Item ID: D206-667-103TRN

Item Name: Crosstube Turning Detaill

DART AEROSPACE LTD	Work Order:	107544
Description: Crosstube Assembly (206L High Fwd)	Part Number:	D206-667-143
Inspection Dwg: D206-667-143 Rev: C		Page 1 of 2

DRAWING NO. D206-667-143	TITLE CROSSTUBE ASS'Y (206L HIGH FWD)	REV. C	DART AEROSPACE LTD ENGINEERING ORDER		D.E.O. NO. D206-667-143-C-1	SHEET NO. SHEET 1 OF 1	SCALE NTS
DRAWN 97	CHECKED ASS	MFG. APPR. [Signature]	APPROVED WD		DE APPR. [Signature]		
DATE 11.07.15	DATE 11.07.20	DATE 11.07.21	DATE 11/07/21		DATE 11.07.21

TURNING DETAIL

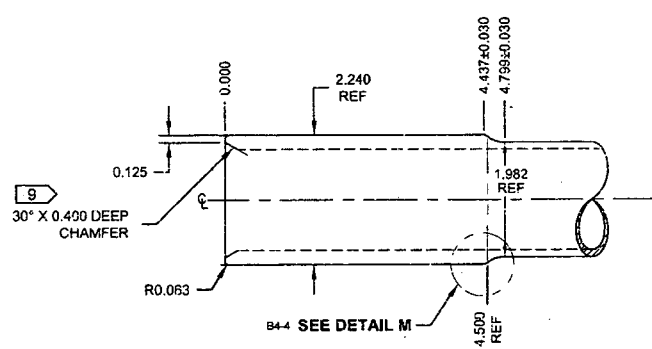
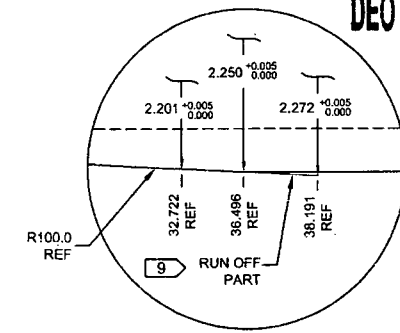
C	REVISE GENERAL NOTES/PART LIST (ZN D7-1); REORGANIZED VIEWS AND REFORMATTED DRAWING TO CURRENT STANDARDS. D3595-063-395 WAS D2856-400-694 (ZN D6-2 & A5-2); REMOVED REF. & ADD TOLERANCE (ZN D3-3, C4-3, C5-3); RELOCATED FLAG #6 (ZN A8-3) PER NCR 210; MOVED TURNING DETAIL & UPDATED TOLERANCE TO SHEET 4.	RF	08.11.06
B	ADD HOLES AND NUT PLATES FOR COMPATABILITY WITH BHT/AA SKUDTUBES	PH	05.07.26
A	NEW ISSUE	CP	00.11.17
REV.	DESCRIPTION	BY	DATE
DESIGN	97	DART AEROSPACE LTD	
DRAWN	RE	HAWKESBURY, ONTARIO, CANADA	
CHECKED	97	DRAWING NO.	REV. C
MFG. APPR.	97	D206-667-143	SHEET 1 OF 4
APPROVED	97	TITLE	SCALE
DE APPR.	97	CROSSTUBE ASS'Y (206L HIGH FWD)	NTS
DATE	08.11.06	COPYRIGHT © 2000 BY DART AEROSPACE LTD THIS DOCUMENT IS PRIVATE AND CONFIDENTIAL AND IS SUPPLIED ON THE EXPRESS CONDITION THAT IT IS NOT TO BE USED FOR ANY PURPOSE OR COPIED OR COMMUNICATED TO ANY OTHER PERSON WITHOUT WRITTEN PERMISSION FROM DART AEROSPACE LTD.
